**Re: Power to Amend/Repeal Instrument or a Decision – Section 24AA Acts Interpretation Act 1954**

**(AMENDED 15 SEPTEMBER 2020) Negotiated Decision Notice about request to change development approval**  
*(Given under section 76 of the Planning Act 2016)*

**Application Number:** COM002-18/19  
**Description:** COMBINED APPLICATION  
Material Change of Use for a Public Facility - Other  
(Solar PV Power Station (Solar Farm) and Associated  
Facility Switchyard and Electrical Transmission Line)  
Reconfiguring a Lot for Subdivision by Agreement (10  
Lease Areas)  
**Level of Assessment:** *Impact Assessable*  
**Site Address:** 480 Tomlins Road, Goovigen  
Lot 38 Tomlins Road, Dixalea  
Lot 18 Dodsons Road, Dixalea  
Lot 37 Hibbs Road, Goovigen  
5460 Dodsons Road, Ulogie  
Lot 33 Dodsons Road, Ulogie  
**Lot & Plan Details:** Lot 39 on RN395  
part of Lot 28 on RN211  
part of Lot 18 on RN271  
part of Lot 37 on RN1147  
Lot 29 on RN210  
Lot 32 on RN194  
Lot 33 on RN210

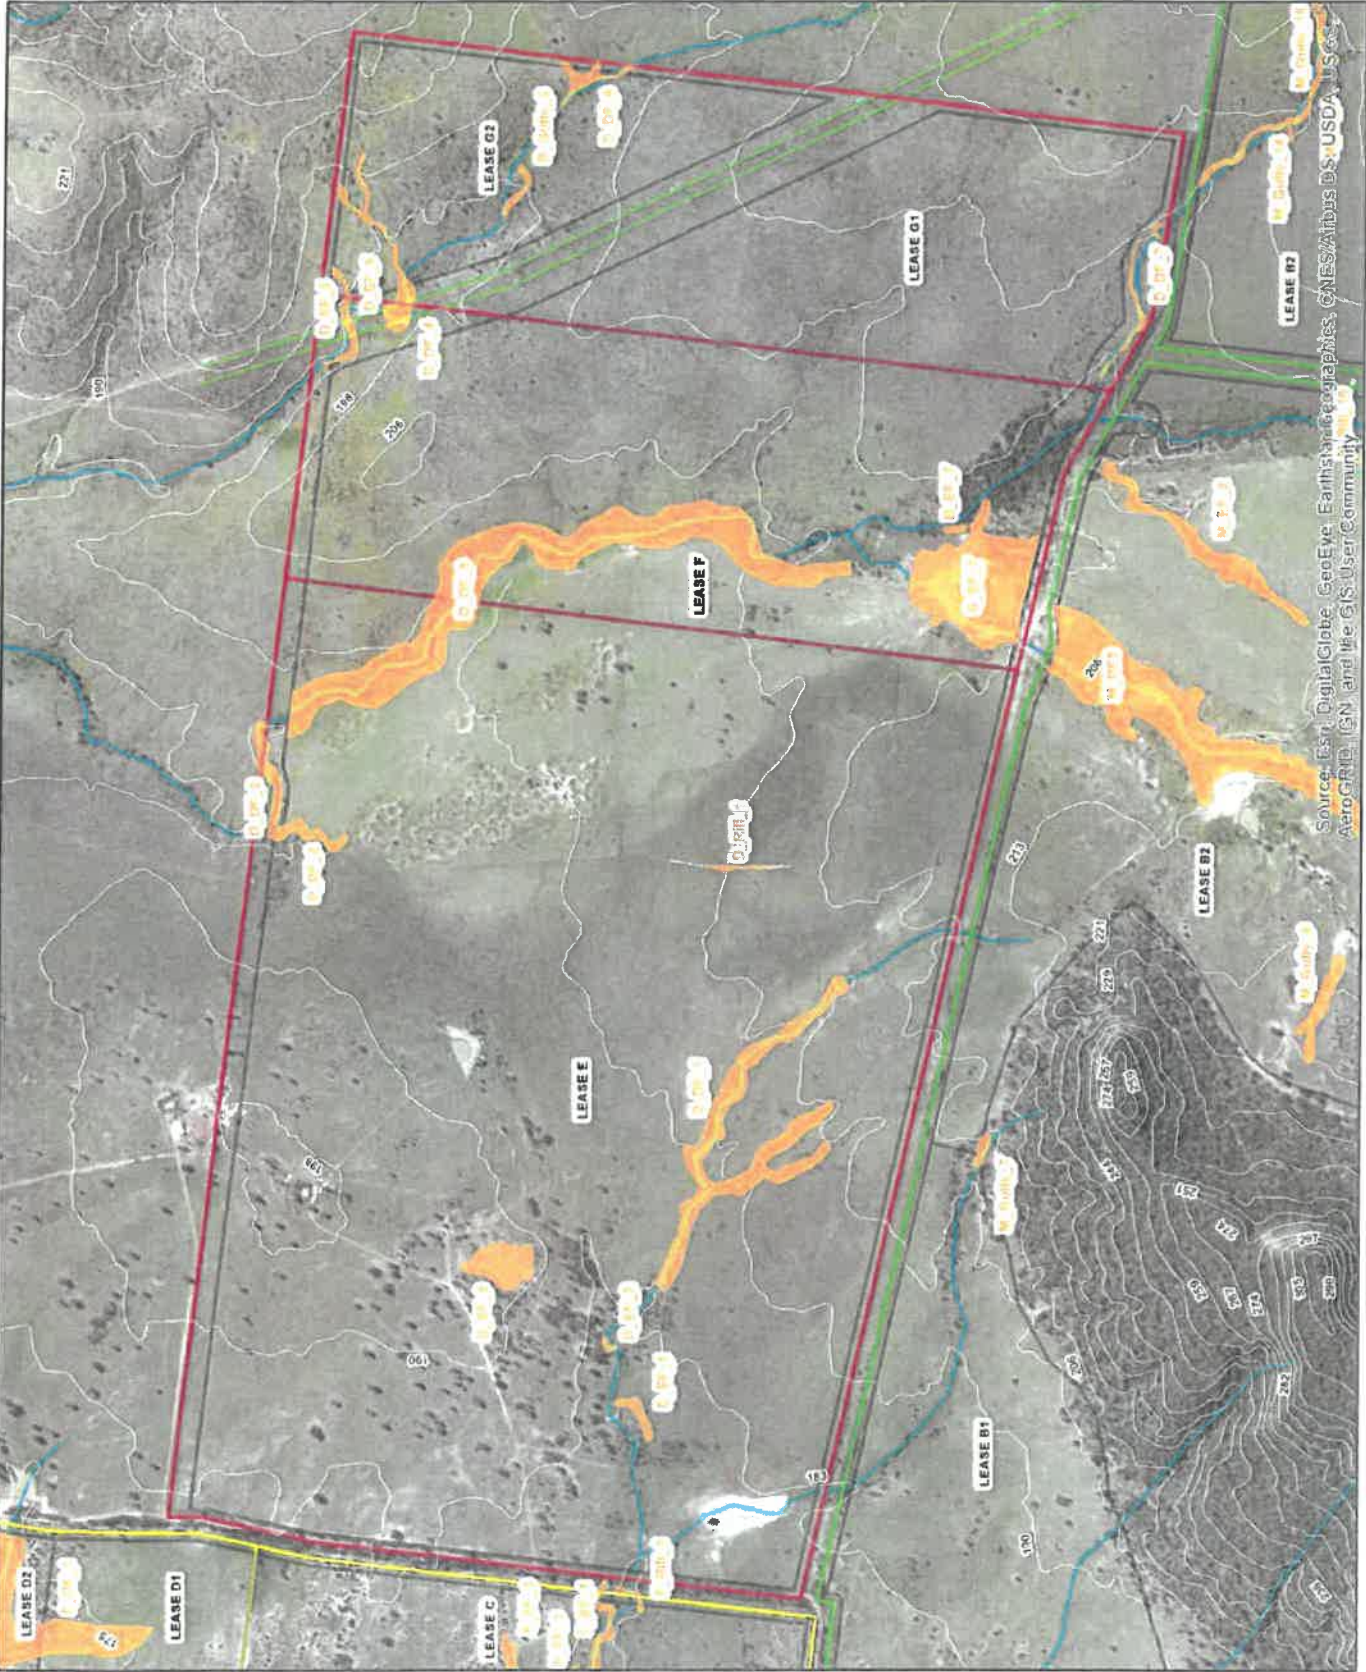
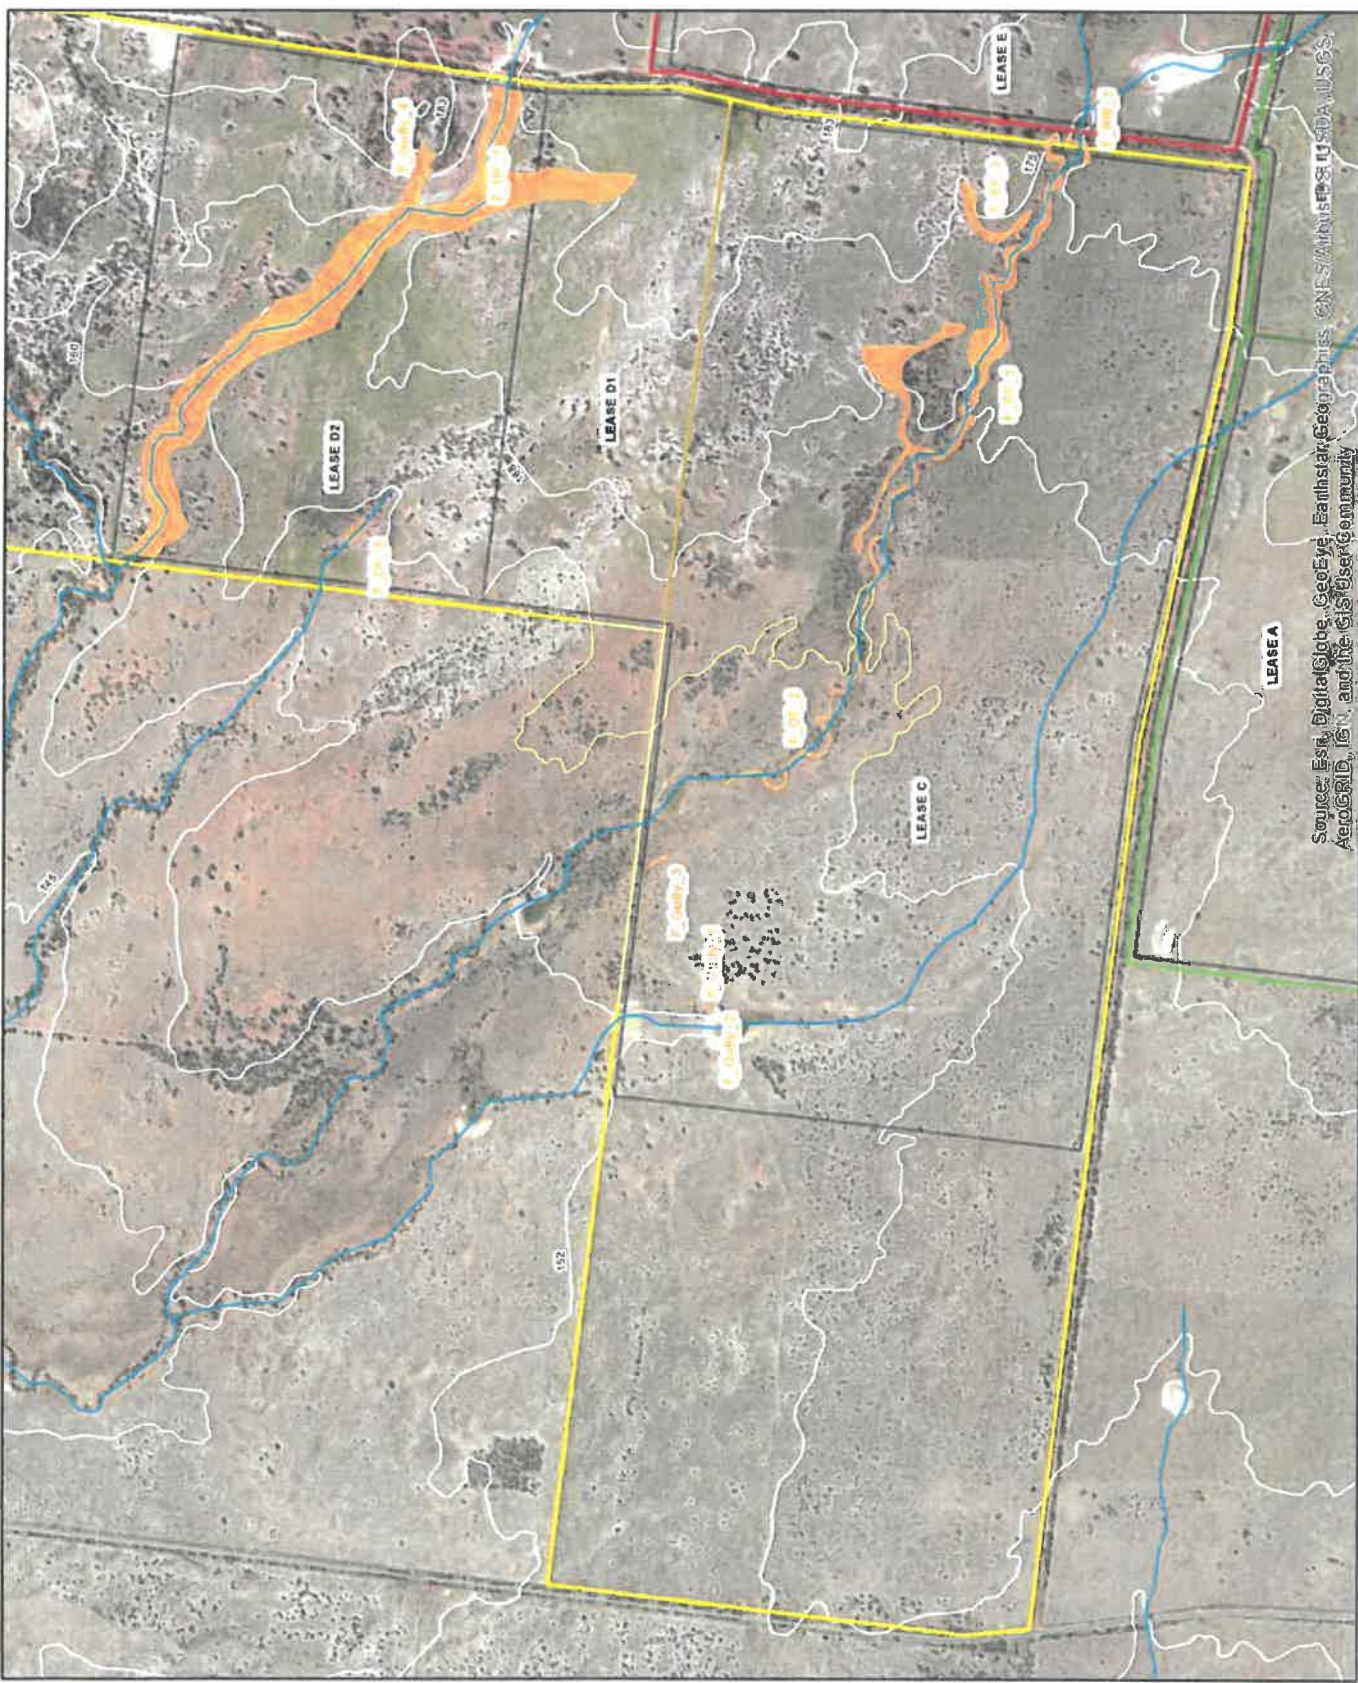
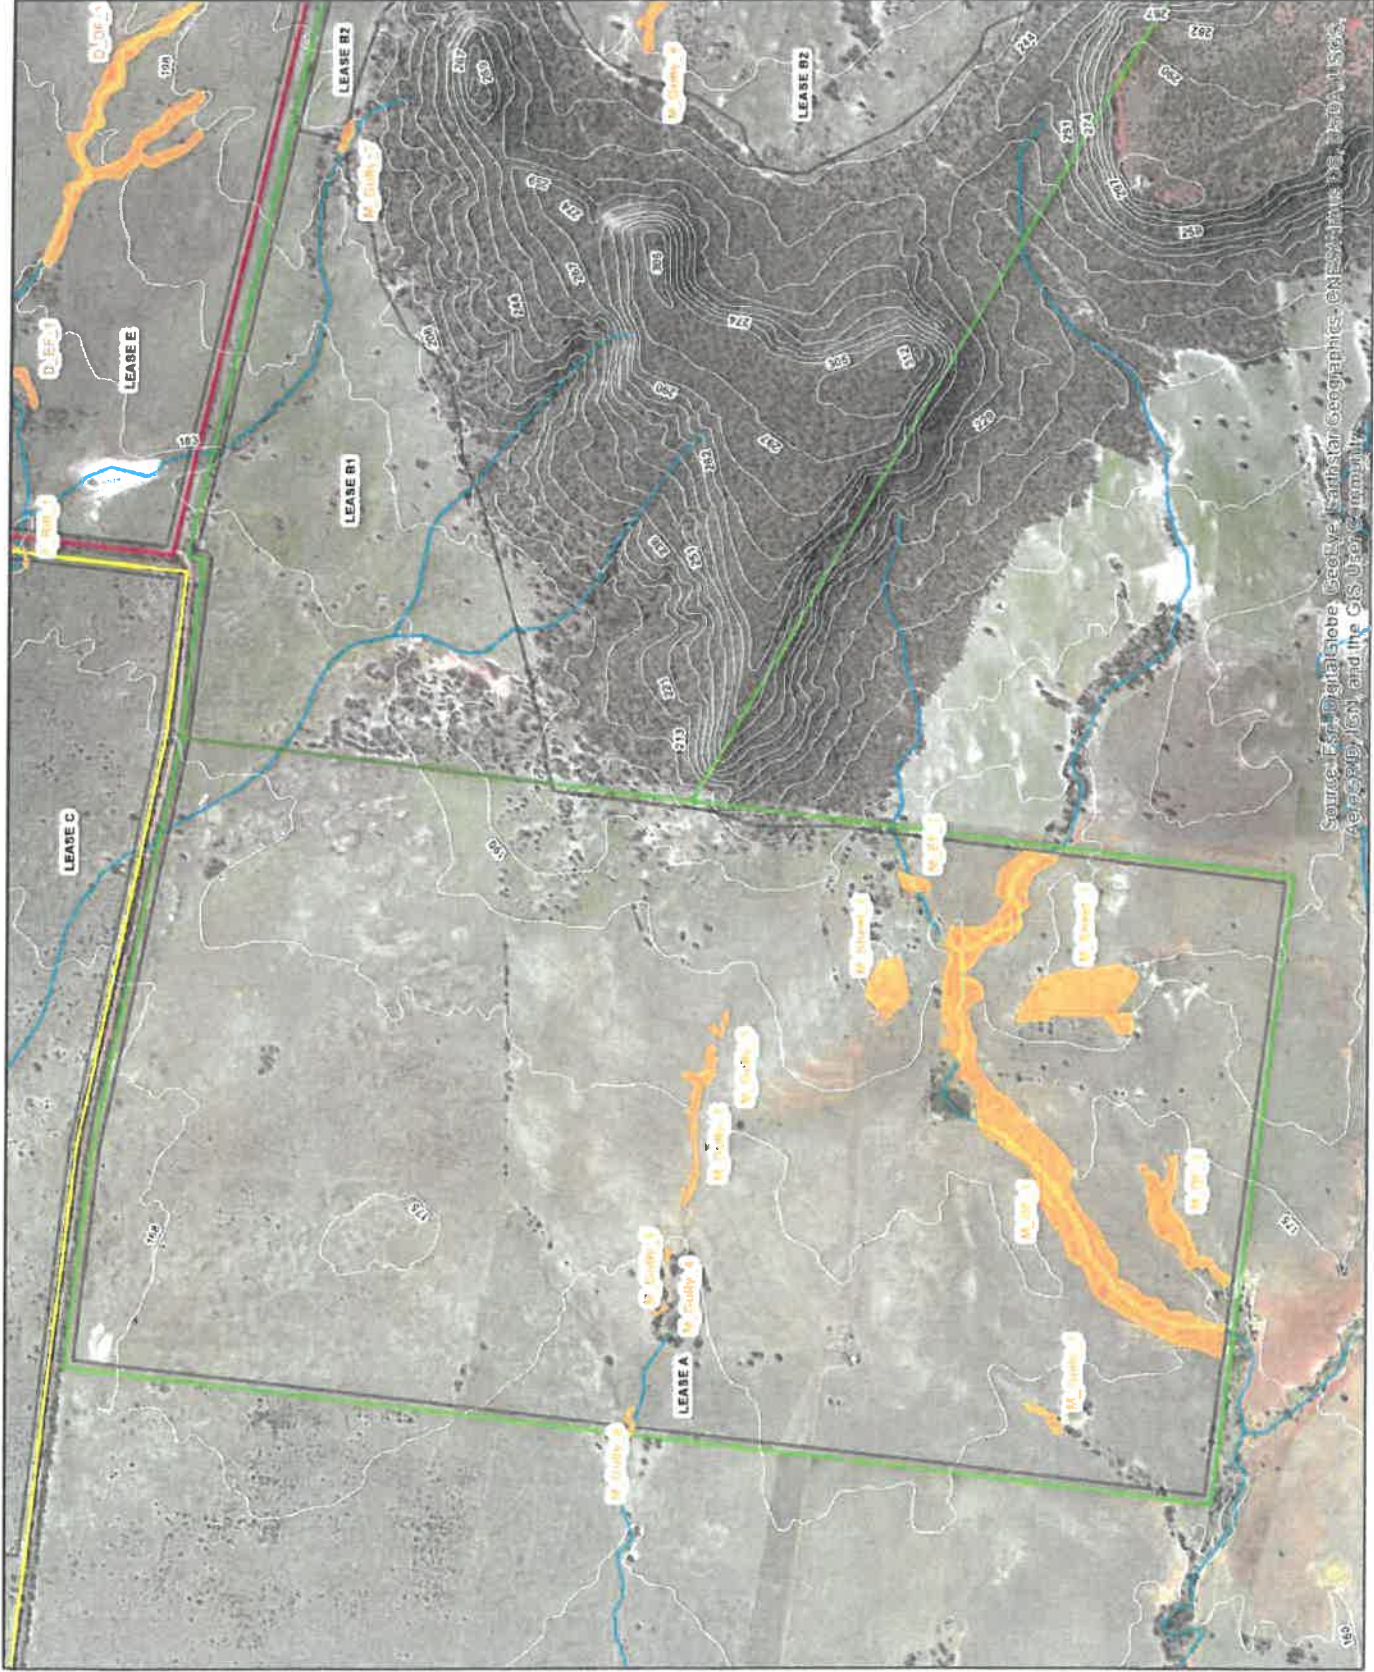
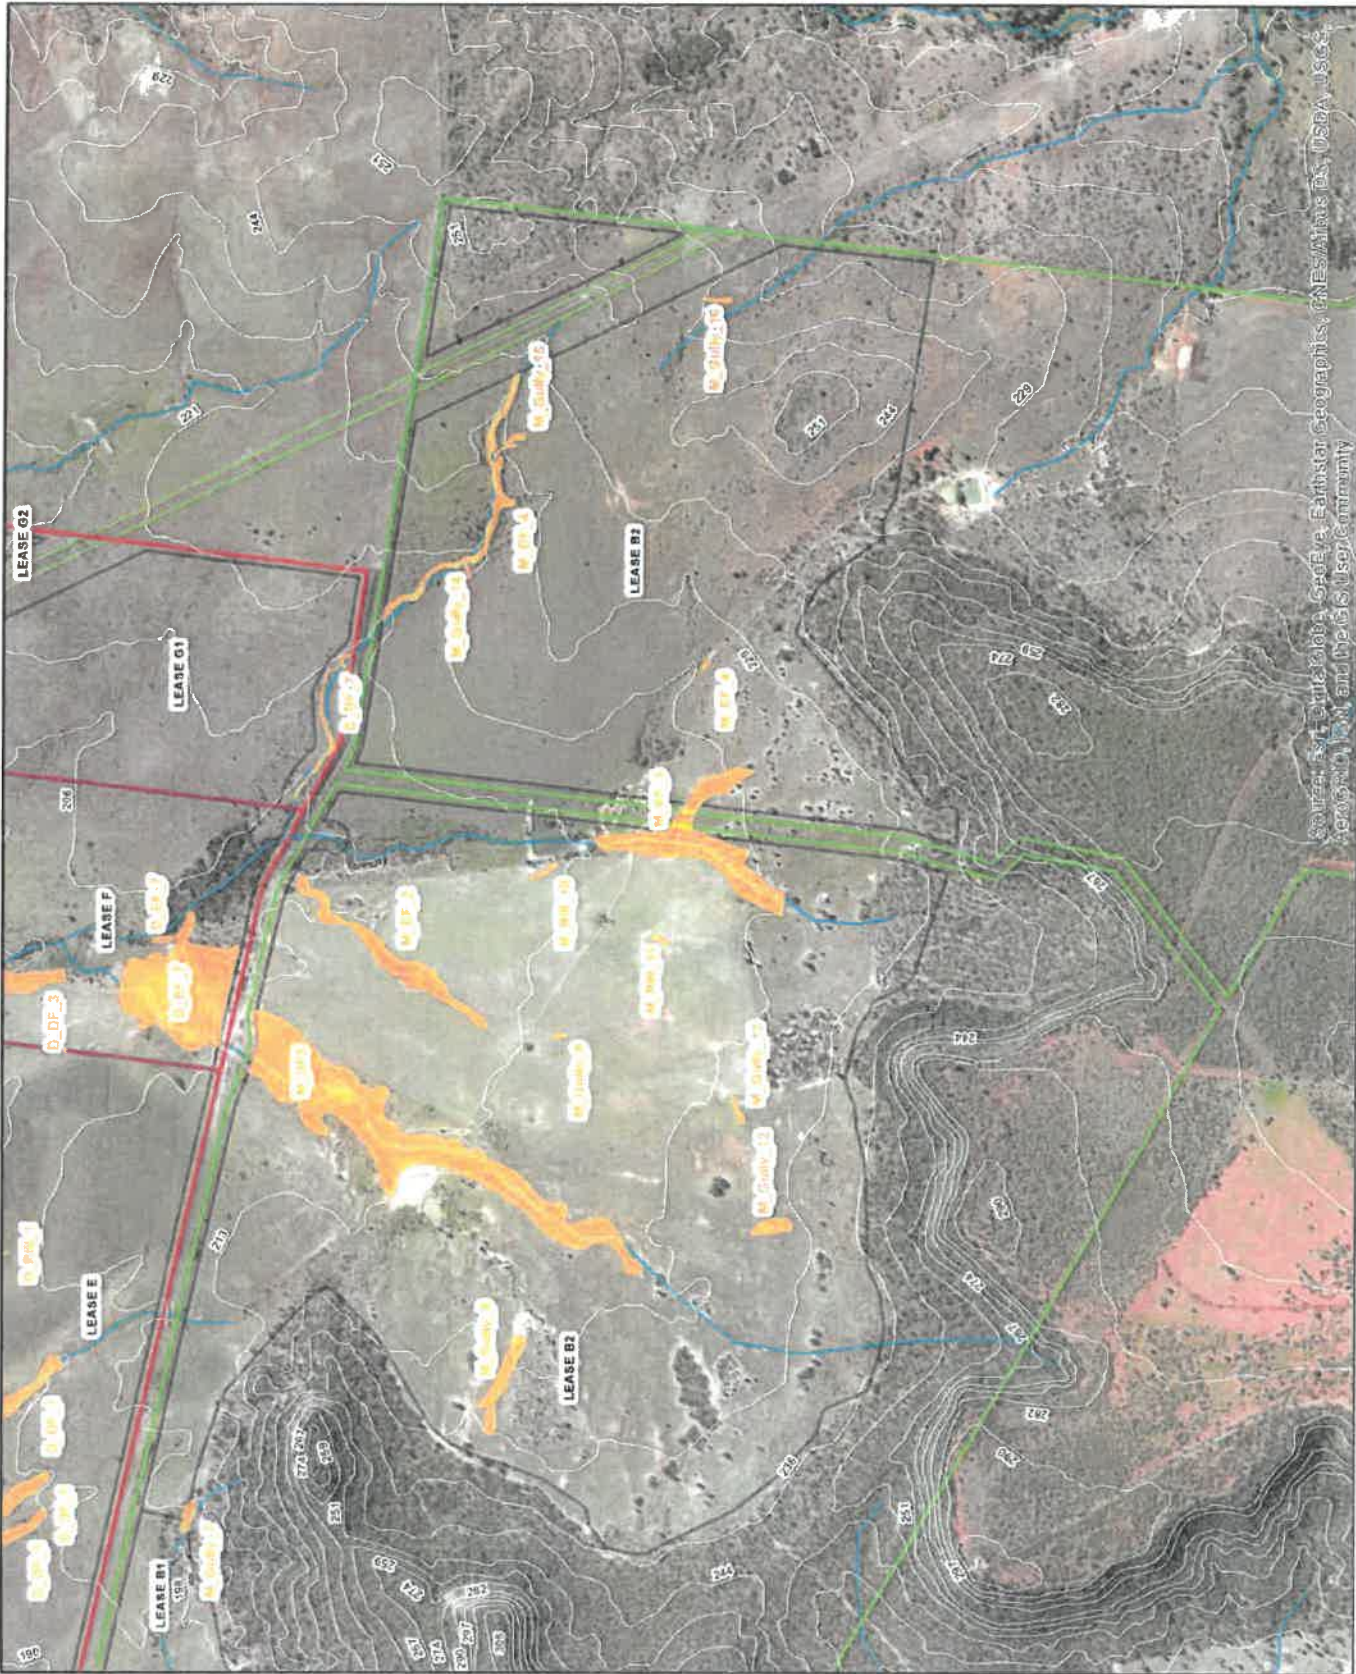
5. **(Amended 11 December 2019)** Submit an amended Project Proposal Plan that excludes solar array panels or other improvements from any areas identified as land degradation features in Figures 7, 8, 9 or 10 of the approved Land Condition Assessment including suitable buffers. **Council may accept solar arrays over areas which are rehabilitated prior to establishing the structures subject to satisfactory evidence being provided to Council of the rehabilitation.**
